|  AQUILA Aviation DOA Nr.: EASA.21J.025 | Technische Mitteilung / Service Bulletin | Dokument Nr.: SB-AT01-043 |

Nachrüstung untere Cowling kompatibel mit Ölsumpf am Turbolader und verbesserte Kabinenheizung / Retrofit of a lower cowling compatible with the oil sump on the turbo charger and an improved cabin heating

Retrofit of a lower cowling compatible with the additional oil sump on the turbocharger introduced by Rotax 2023 (see SI-914-039) and an improved cabin heating.

Umbau Ölsystem

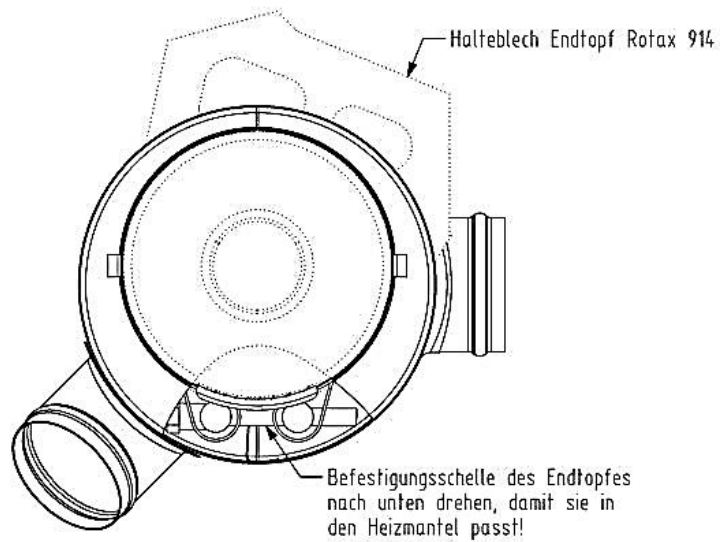
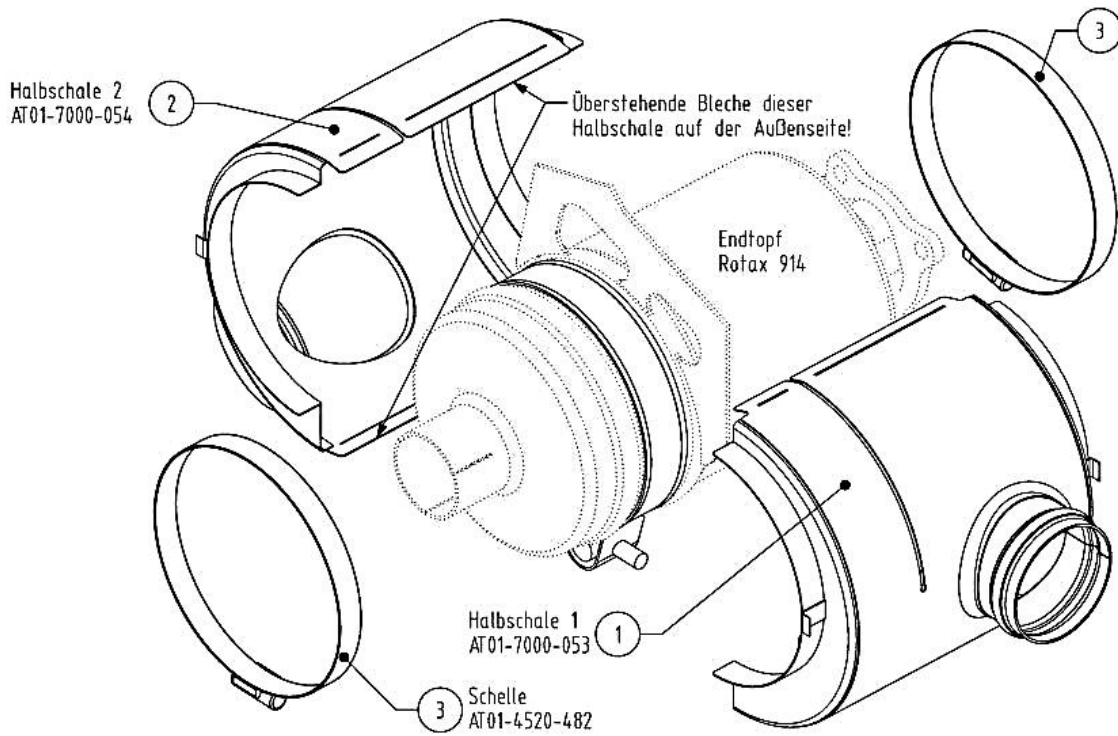
- Wechsel Öl-Rücklaufleitung (alt: AT01-7000-032-R01 neu: AT01-7000-048-R00ff)
- Austausch Ölkühler Halteblech (alt: AT01-7050-151-R03 neu: AT01-7050-155-R00ff)
- Ölschläuche zu/vom Ölkühler neu verlegen (zusätzl. Winkelverschraubung AT01-4520-162)

Austausch Heizmantel

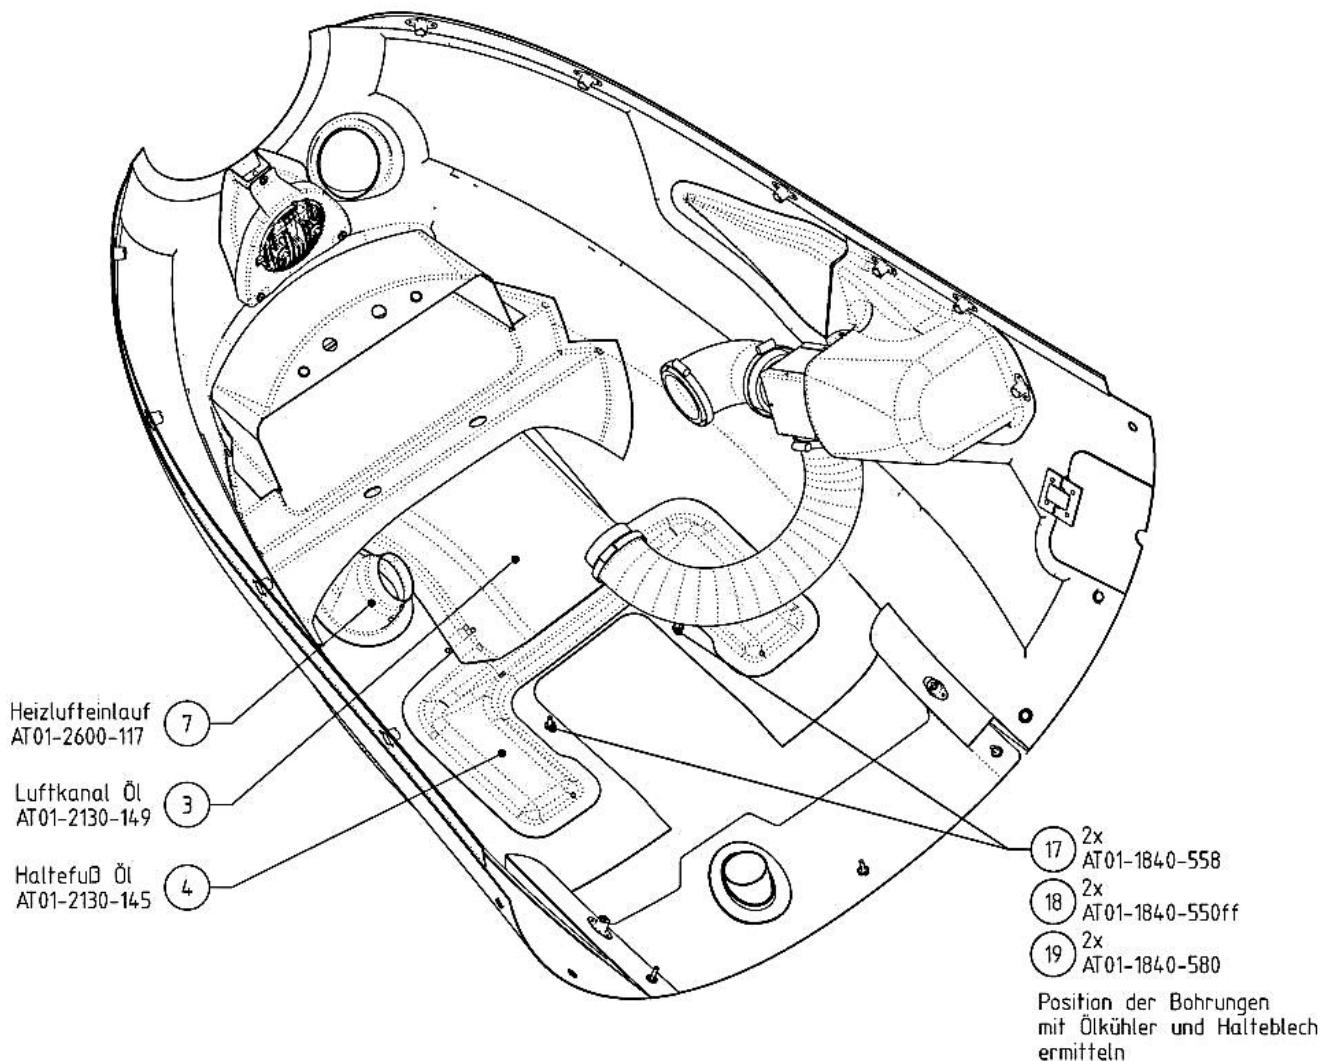
alt: AT01-7000-030-R00

neu: AT01-7000-029-R00ff

zu beachten: Halteschelle Endtopf nach unten drehen, damit sie in den Heizmantel passt!

Umbau / Austausch untere Cowling (auf Stand AT01-2130-018-070-R01ff)

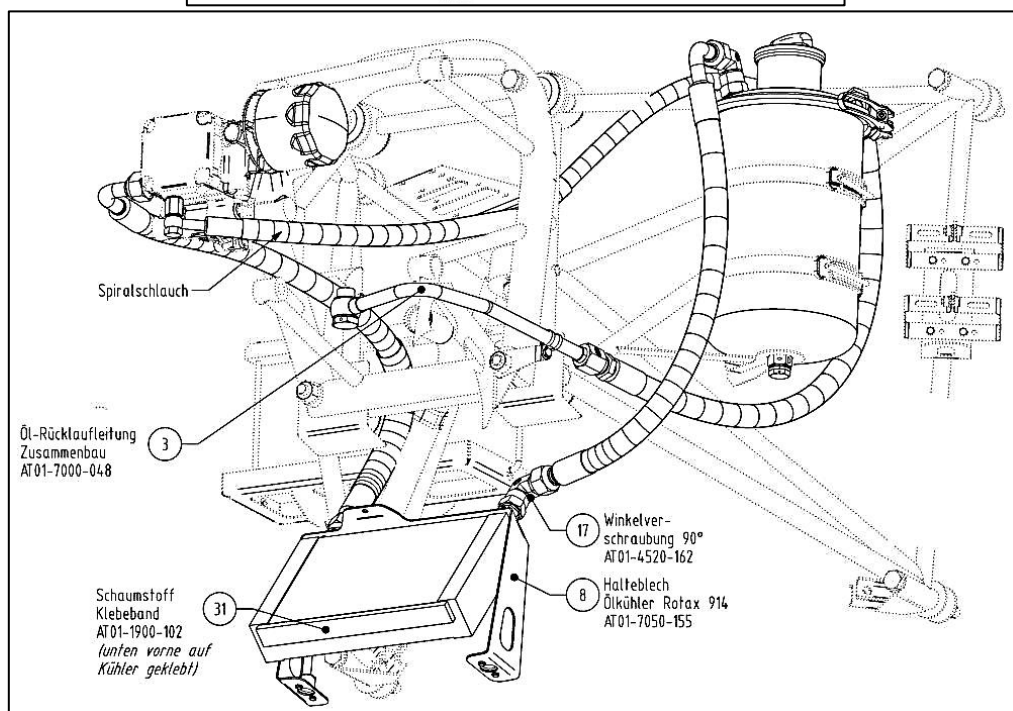
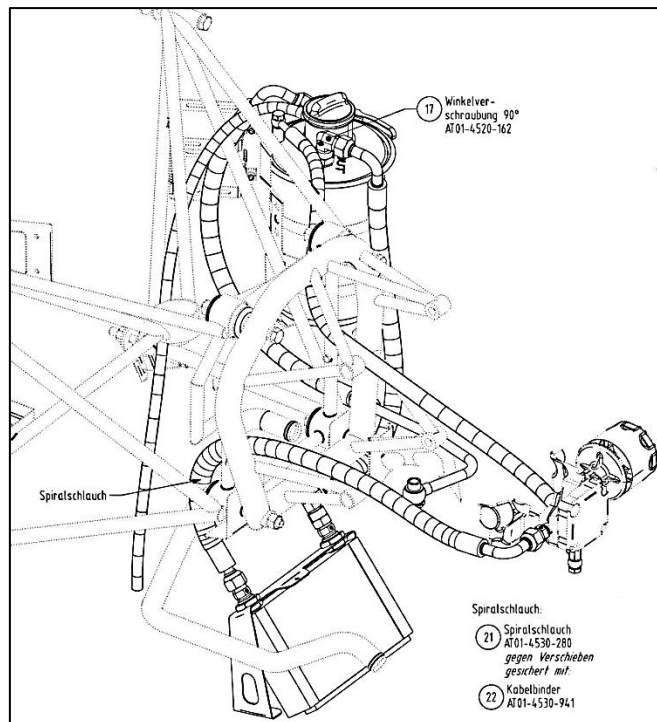
- Austausch Luftkanal Ölkühler
(alt: AT01-2130-025-R00 neu: AT01-2130-149-R00)
- Wechsel Haltefuß Ölkühler
(alt: AT01-2130-144-R01 neu: AT01-2130-145-R00)
- Wechsel Heizlufteinlauf
(alt: AT01-2600-016-R00 neu: AT01-2600-117-R00)
- ggf. Wechsel Luftkanal Wasserkühler oben & unten
(AT01-2130-027 & -028)

zu beachten: Drainagebohrungen $\varnothing 5\text{mm}$ an den tiefsten Stellen: links, rechts und im Ölkühler-Kanal sowie im Heizlufteinlauf

Retrofit of oil system

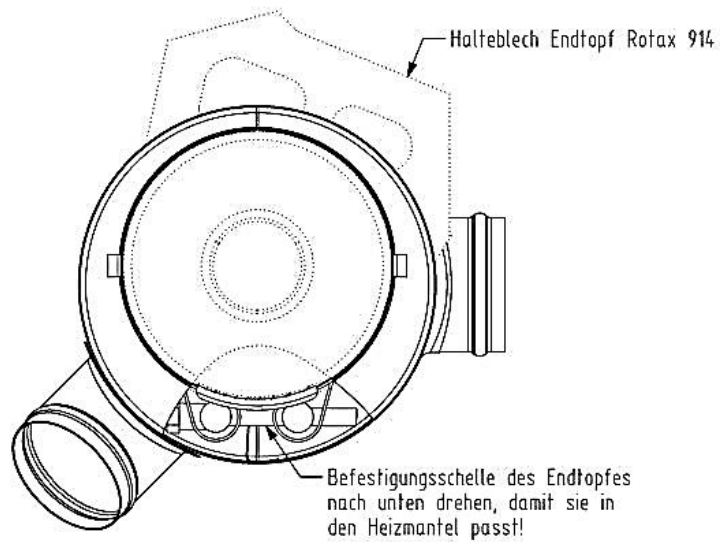
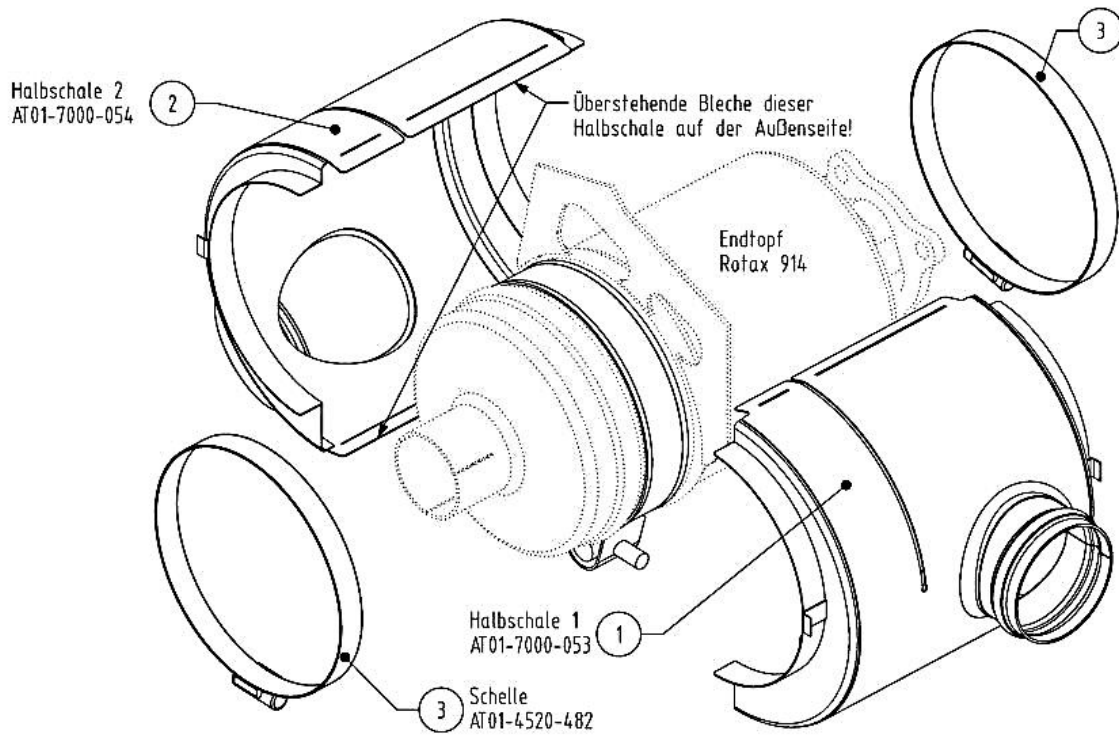
- exchange of oil return hose (old: AT01-7000-032-R01 new: AT01-7000-048-R00ff)
- exchange of oil radiator bracket (old: AT01-7050-151-R03 new: AT01-7050-155-R00ff)
- reroute of oil hoses from/to oil radiator (additional elbow fittings AT01-4520-162)
